4709 ROOSEVELT WAY NE

SDCI # 3038322-EG | MUP # 3036766-LU

RECOMMENDATION MEETING

01.30.2023

EDG 2 STREET EDGE

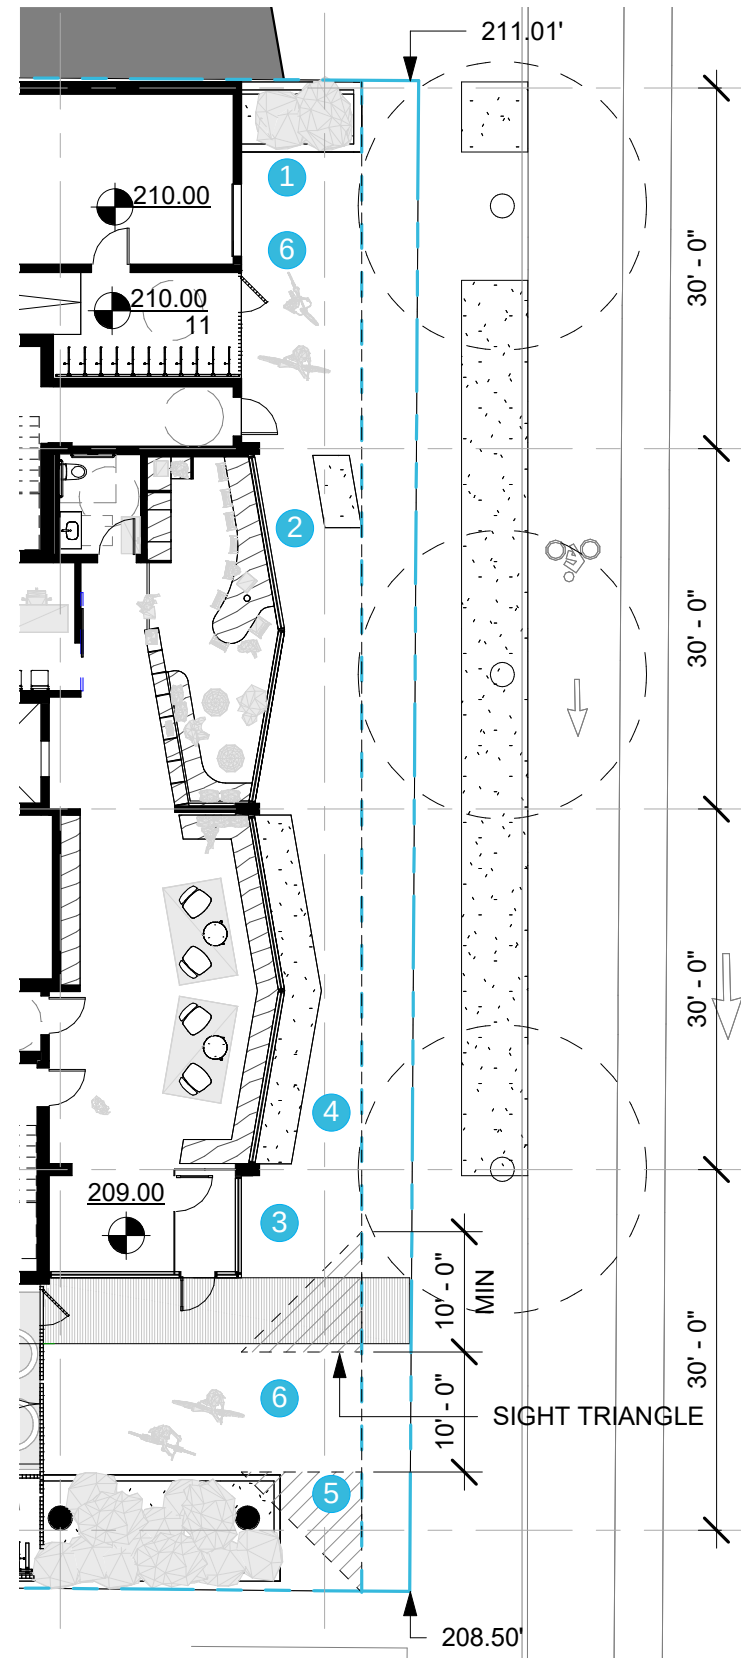
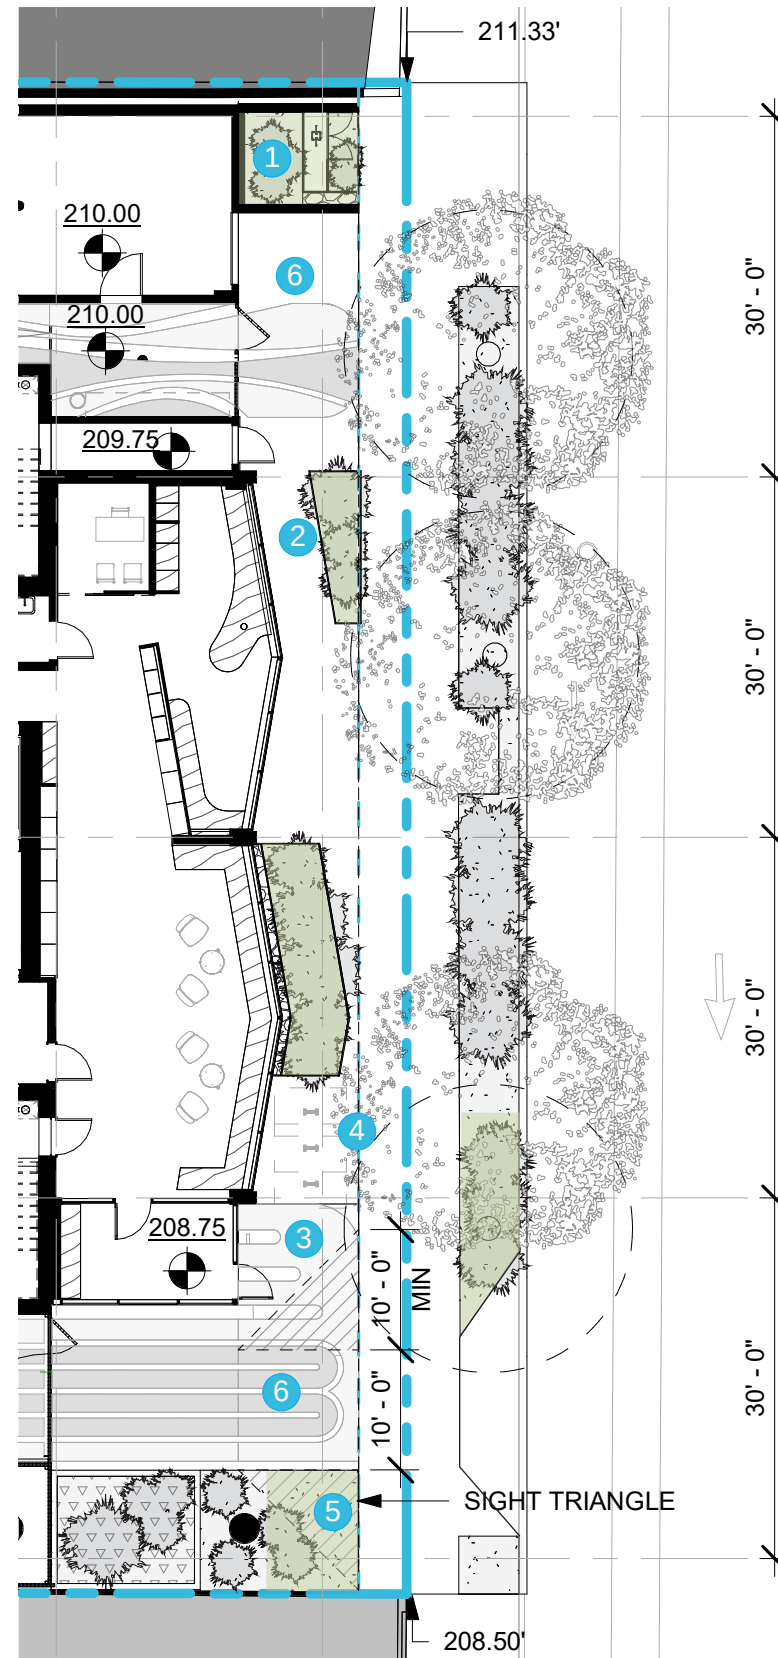
e. The Board supported the overhead weather protection along the street and found the weather protection helped to frame the entries into the building. The Board supported the street level articulation the design provides and requested additional information in the Recommendation packet on how to further activate the sidewalk space and how that space will be furnished or landscaped. To this end, the Board recommended the applicant include a study in the Recommendation packet to provide details on how pushing the interior street level spaces closer to the property line will be used. (PL2-C, University Supplemental Guidance DC2-3-a, PL3-3-a)

At EDG 1: :The Board requested the amenity space [street level residential uses] provide the flexibility to permit a future commercial space(s) to provide for street activation. The Board requested the applicant study the adaptability of the amenity space to convert to commercial spaces in the future."

The design team provided a study at EDG 2 demonstrating how a portion of the street level accessory residential uses could have the possibility to be converted in the future to retail uses. There are no commercial uses proposed at this time. The street level has been optimized as much as possible to maximize places for people to live above. (Please see design goals p. 6.) Expanding the street level to be closer to the property line would require additional GFA that would be chargeable FAR. At the time of MUP intake, the project is effectively at the allowable GFA / FAR limit. (Please see FAR calculations and GFA area plans in the appendix p.102-103.)

Per the Board's request, the studies on the left show the amount of GFA the project would have to remove from the apartments above to increase street level accessory residential uses closer to the property line. There would be no increase in commercial uses, as no commercial uses are proposed at this time.

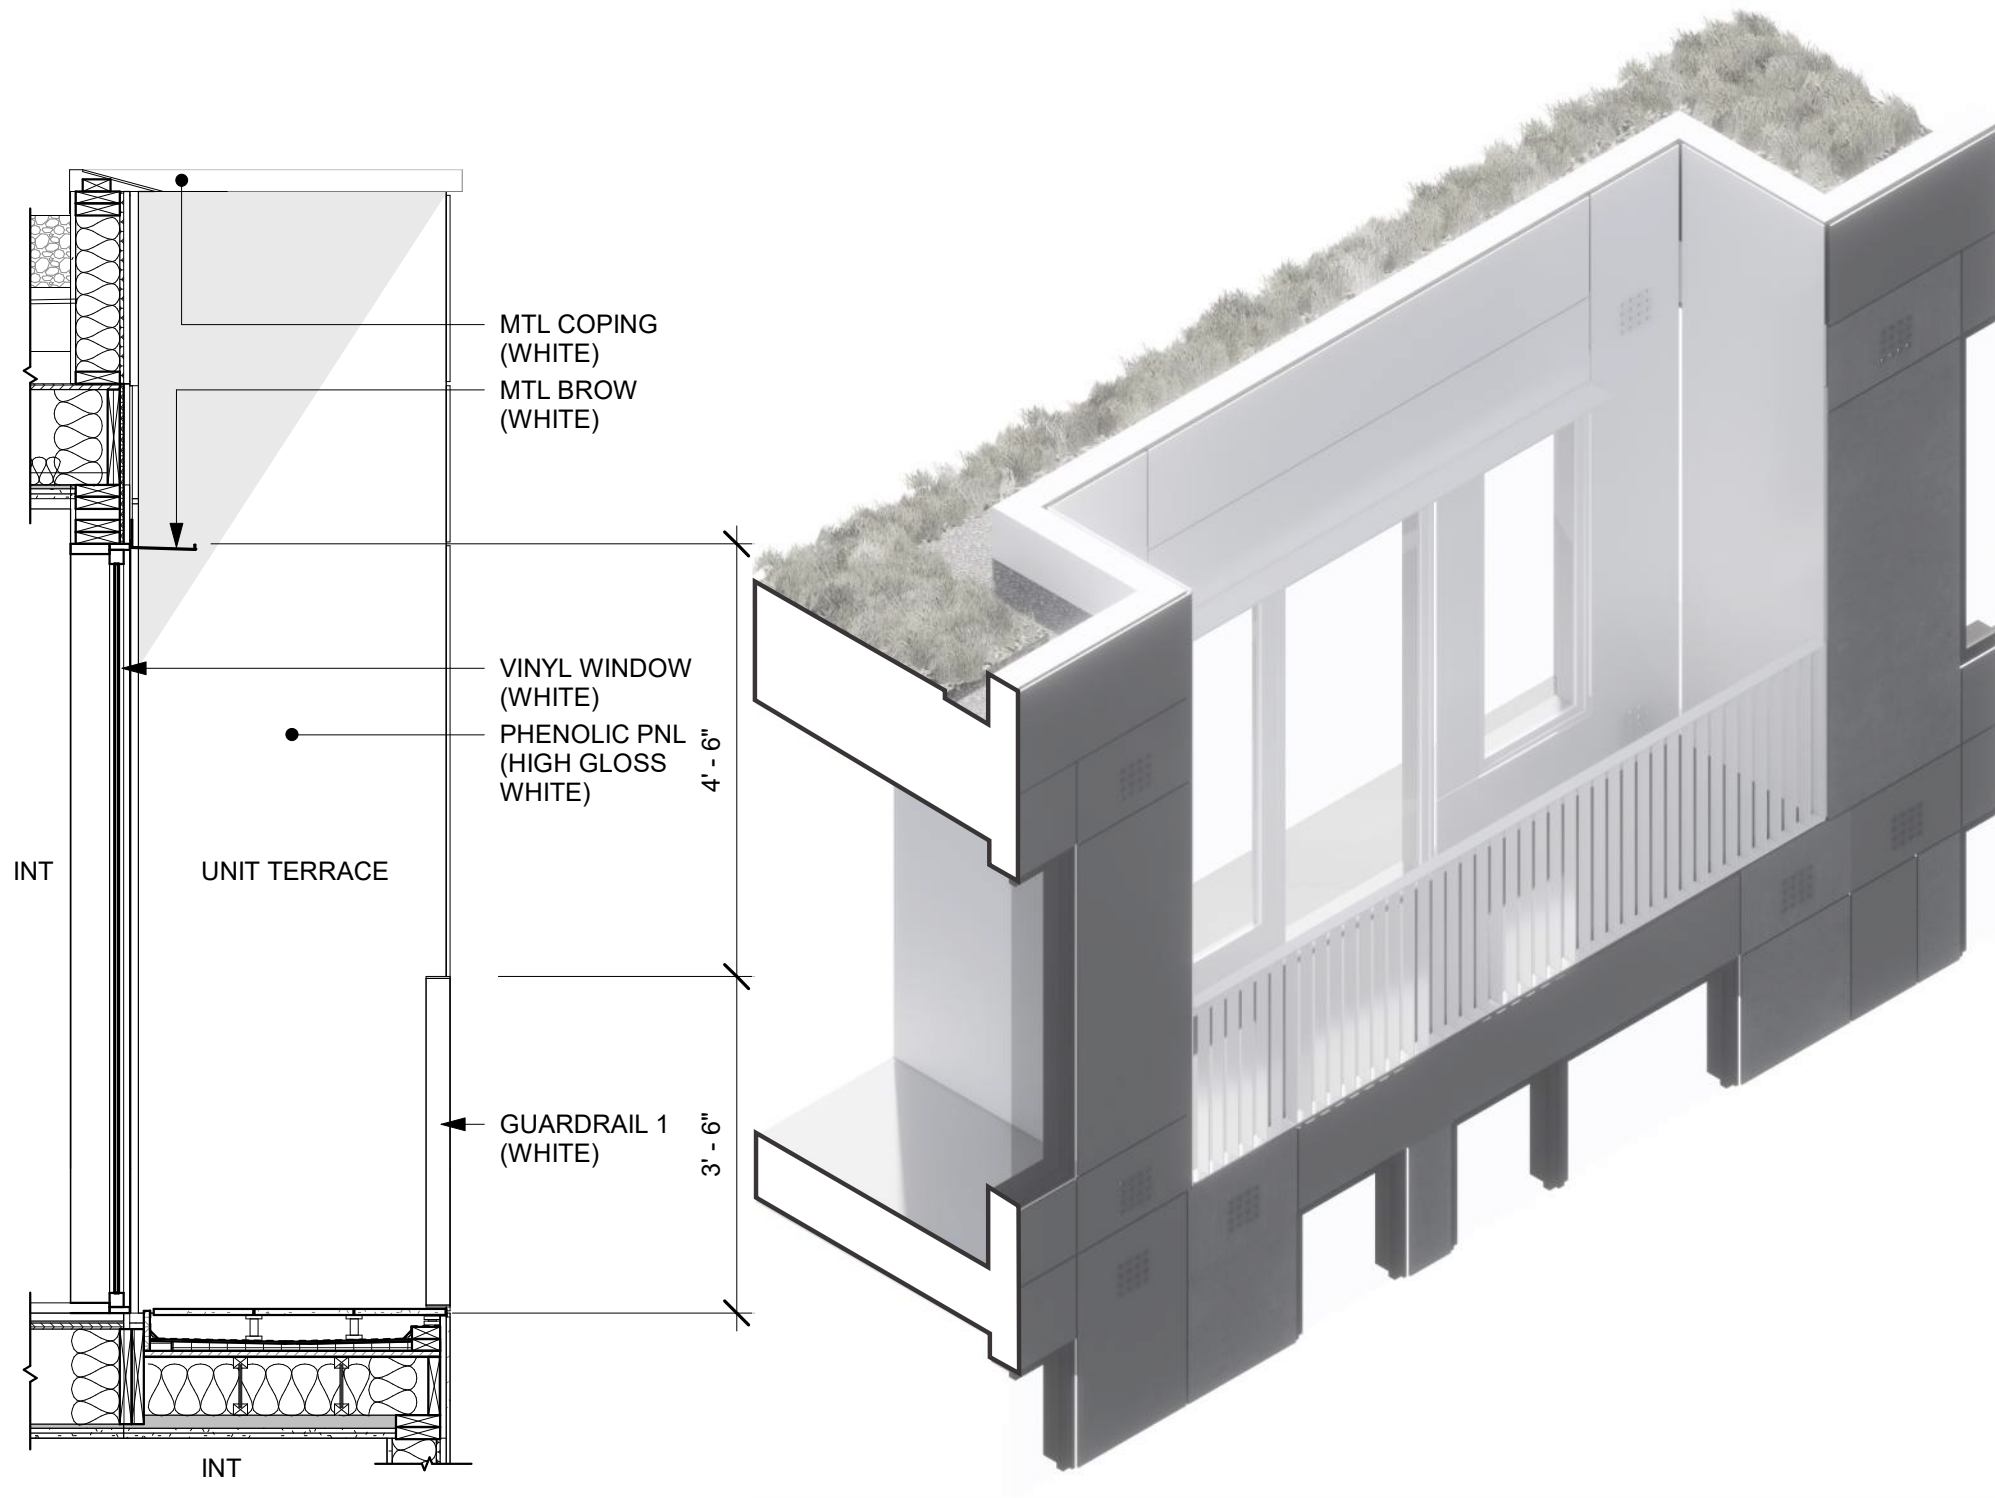
f. Board members requested details on the exterior materials to be used and how they will be incorporated in to the buildings design. The Board stated that the quality and details of the exterior materials are important with the relatively simple massing of the building. The Board requested details on the upper level steps on the west façade of the building and demonstrating how the steps will distinguish themselves from the overall mass of the façade. (DC4-A, University Supplemental Guidance DC4-1)

Design Response:
The board supported facade concept and patterning remains. The exterior materials for the "mid-rise block" are through color cementitious panels with a matte finish mixed with phenolic panels in a matching tone a hue with a glossy finish. The contrasting glossy and matte panels adds variety to the overall facade.

EAST FACADE INSET | TYPICAL PARTIAL AXON

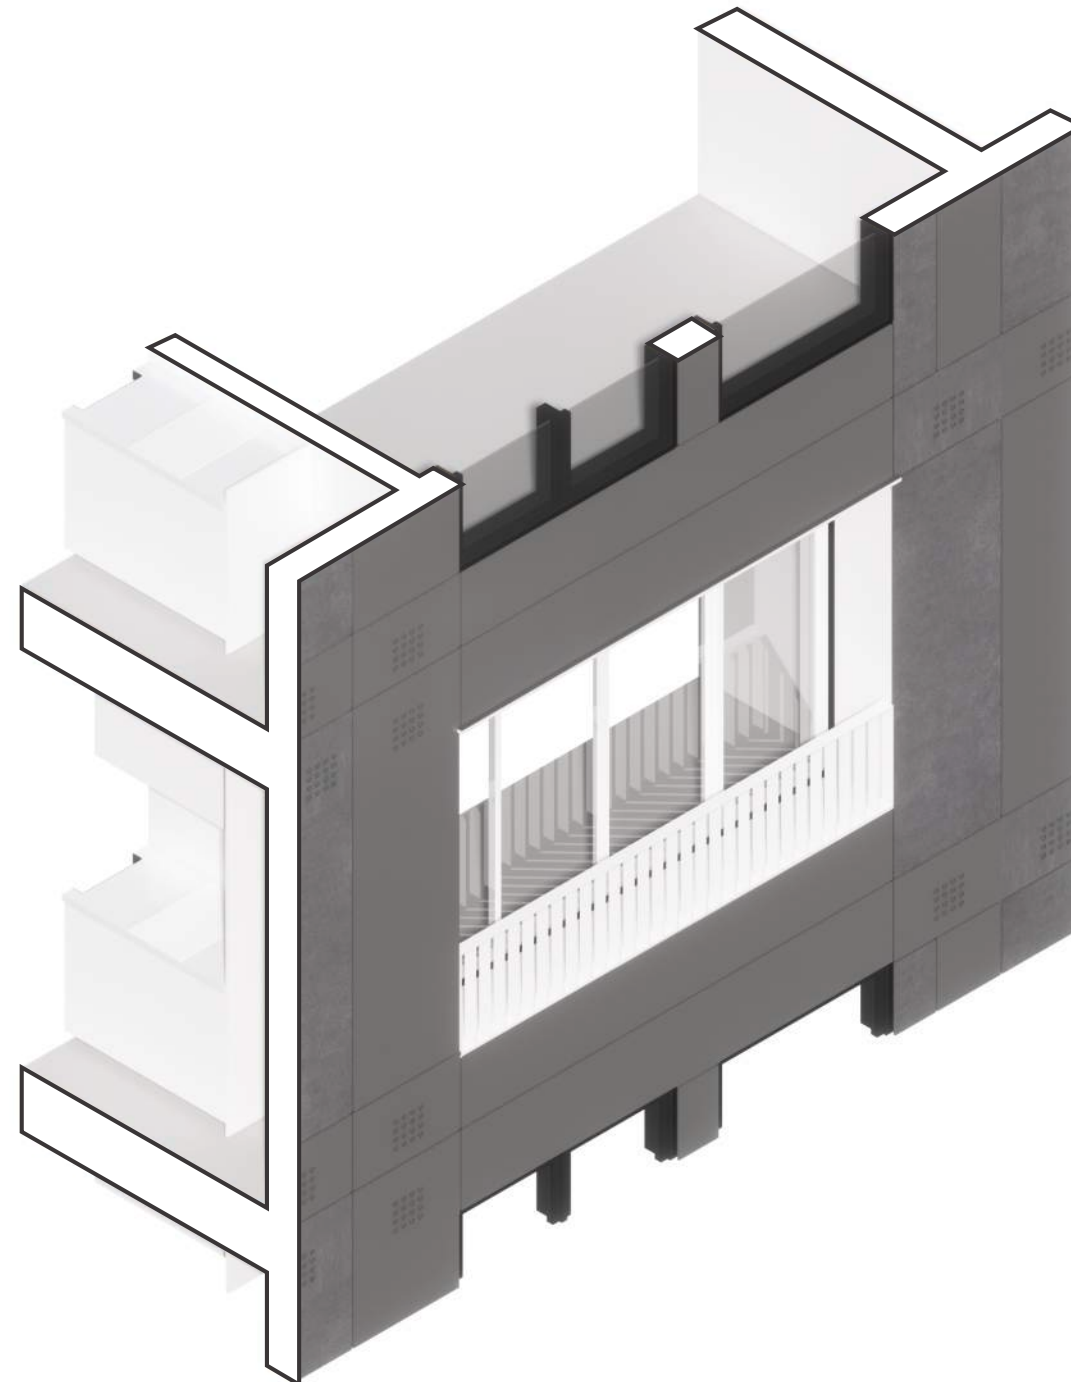
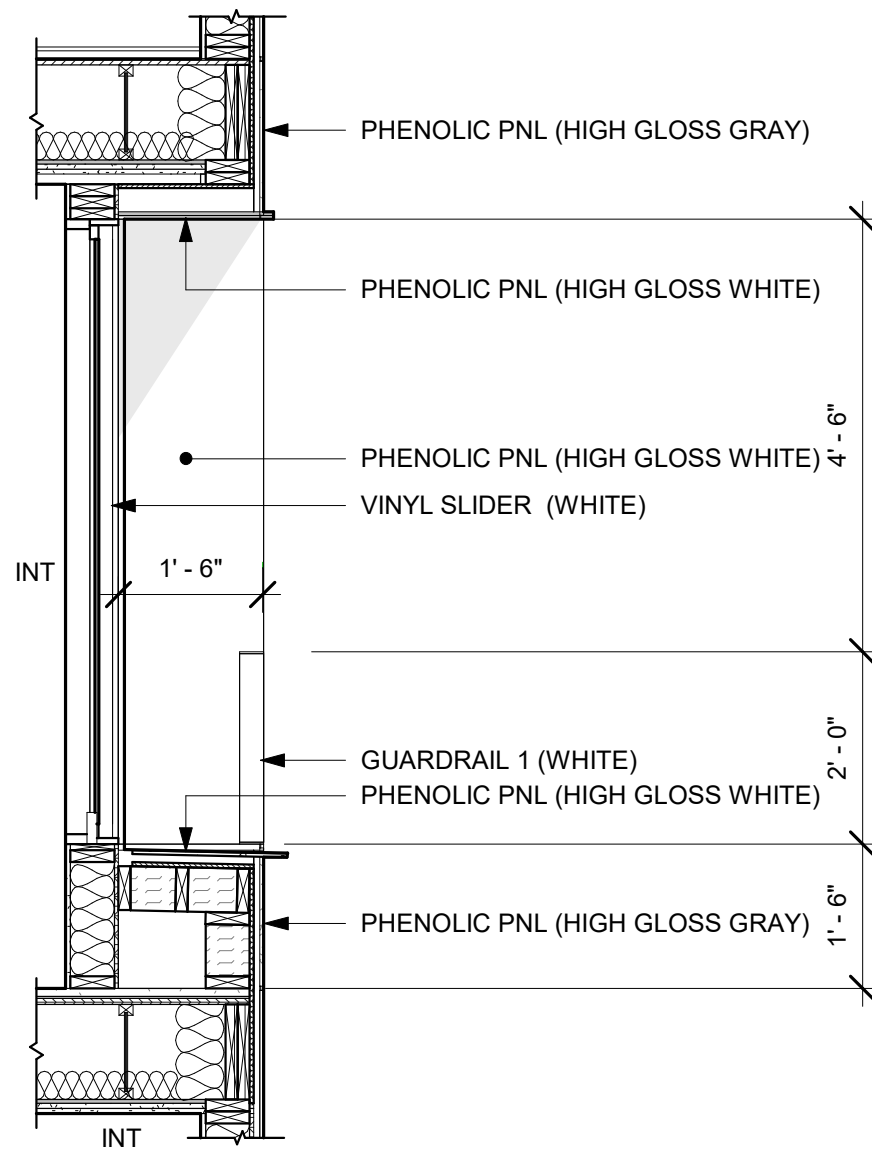
a. The Board found the new façade patterns appropriately tying into the context of the surrounding buildings. Board members noted the second level horizontal datum line's location made sense with the surrounding buildings. The double height entry off Roosevelt Way NE was supported by the Board along with the balconies on the east façade. While the Board supported the balconies facing Roosevelt Way NE, they found the narrow balconies do not provide the same level of use that a wider balcony would allow. The Board recommend the applicant explore ways to increase the balcony depth on the east façade and provide this information in the Recommendation packet. (University Supplemental Guidance – CS2-1-e, DC2-1-a)

Design Response:
The board supported facade concept and patterning remains. This includes the sill height of the street facing apartments. Since the apartments are compact, sills at the exterior window area provides for additional furniture arrangements and flexibility to the interior. The balconies proposed at EDG #2 are "Juliette style" and therefore not occupied. To make the balconies deeper, the compact apartments would have to be reduced or the balconies would be required to project beyond the facade. Projecting over the Street ROW or property line would trigger an annual Street Use permit and need to adhere to SMC 23.53.035 Structural Building Overhangs. SMC 23.53.035 which states: "structural building overhangs shall be removable per Title 15." and thereby not recommended or proposed by the applicant. The Juliette balcony depth were also designed with accessible reach ranges of 24" in mind.
